UNITED STATES PATENT AND TRADEMARK OFFICE

10/578,869

Office Action Summary	Application No. 10/578,869	Applicant(s) SHOJI, HONDA	
	Examiner JOSHUA KING	Art Unit 2828

DETAILED ACTION

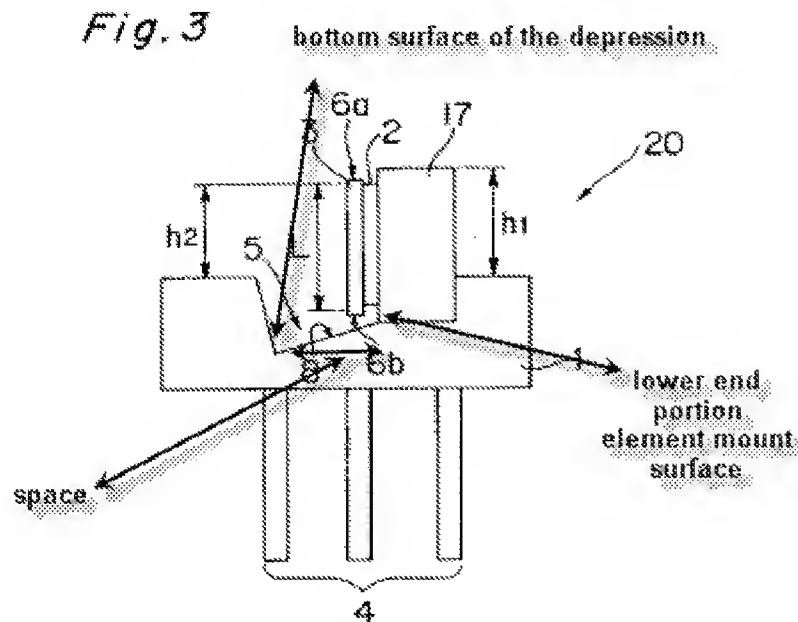
2. Applicant's arguments filed 02/01/2008 have been fully considered but they are not persuasive. In short, the applicant's amendment has not overcome the previous rejection because Hosokawa et al. (U.S. Pre-Grant Publication 2004/0105472) still shows "a lower end portion of the element mount surface and a bottom surface of the depression face each other with a space left there between". The examiner has provided a mark-up of Fig. 3 which shows how this limitation is met by the figure below.

8. Claims 1-7 are rejected under 35 U.S.C. 102(e) as being anticipated by Hosokawa et al. (U.S. Pre-Grant Publication 2004/0105472).
9. **With respect to claim 1**, Hosokawa et al. discloses a base portion having a horizontal top surface (Fig. 3 element 1); a heat sink portion that has a vertical element mount surface and is located above the top surface of the base portion (Fig. 3 element 17); a semiconductor laser element that is fixed to the element mount surface (Fig. 3 element 3); and a depression that is formed in the top surface of the base portion located immediately below the semiconductor laser element so as to receive part of the semiconductor laser element disposed therein (Fig. 3 element 5), wherein the heat sink portion is fixed to the base portion in such a way that the element mount surface is located inward of an inner side surface of the depression (Fig. 3 elements 5 and 17), and that a lower end portion of the element mount surface (Fig. 3 element 17) and a

bottom surface of the depression face each other with a space left there between (Fig. 3 element 5).

3. The examiner recommends applicant considers amending claim 1, to further include a recitation defining how the bottom surface of the heat sink contacts the base portion. As shown in Figs. 3 and 4 of Hosokawa et al., the base portion and heat sink are in full contact over the entire width of the heat sink element. However, as disclosed in Figures 1, 3, and 4 of the instant application the bottom width of the heat sink is shown to overlap the depression. Such a recitation might read as "the heat sink portion is positioned such that the bottom surface of the heat sink portion is not completely

contacted by the base portion, such that the bottom of the element mount surface does not contact the base portion". The examiner believes that such a recitation would overcome the rejection cited in this office action. Please note, that the examiner **IS NOT** indicating any material as allowable, only that such a recitation would overcome the current rejection.
